REQUESTOR NAME: Clean Energy Association of B.C. (CEBC)

INFORMATION REQUEST ROUND NO: 1

TO: BRITISH COLUMBIA HYDRO & POWER AUTHORITY

APPLICATION NAME: 2015 Rate Design Application (2015 RDA)

FRESHET RATE - ANNUAL LOAD & INFLOW PROFILE - ILLUSTRATION

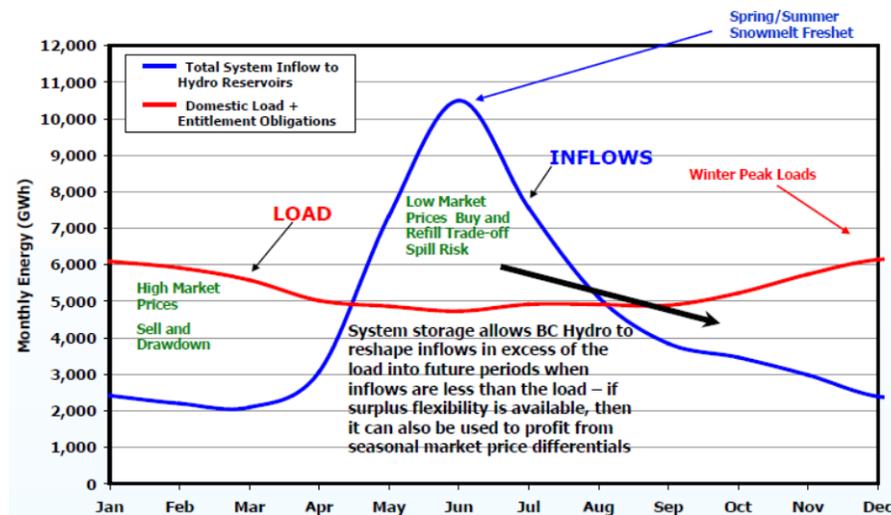
However, as the large note indicates, system inflows do not well define the problem because system storage is generally managed to reshape those flows.

**Figure 8: Wet Year BC Hydro Supply and Demand - Seasonal Profile for 2012**

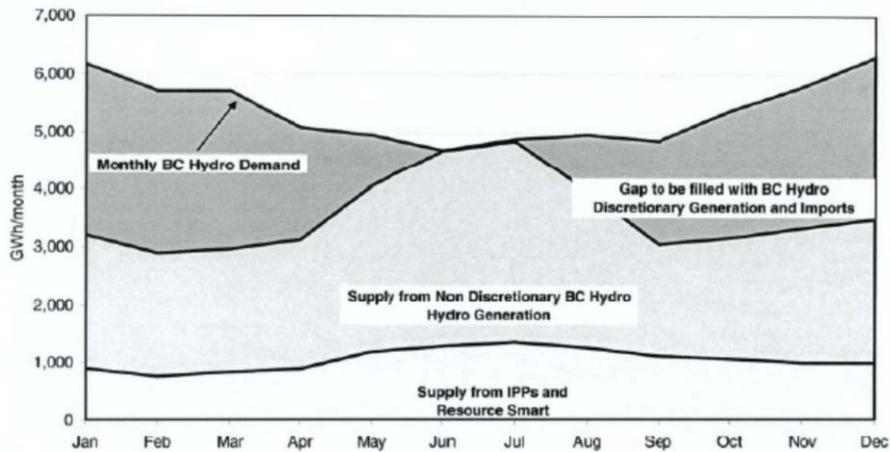
CEBC found this format to be much more illustrative of the extent of the oversupply problem and, in the following information requests, seeks to use a similar format to:

- 1.1 To facilitate a clearer understanding of the recent and current status of the oversupply problem, please provide the historical monthly information in a tabular and chart format similar to the table and chart above, for the actual results in the years 2012 through 2015 (to the extent that 2015 is available). In the tables and charts, please include the following as separate line items:
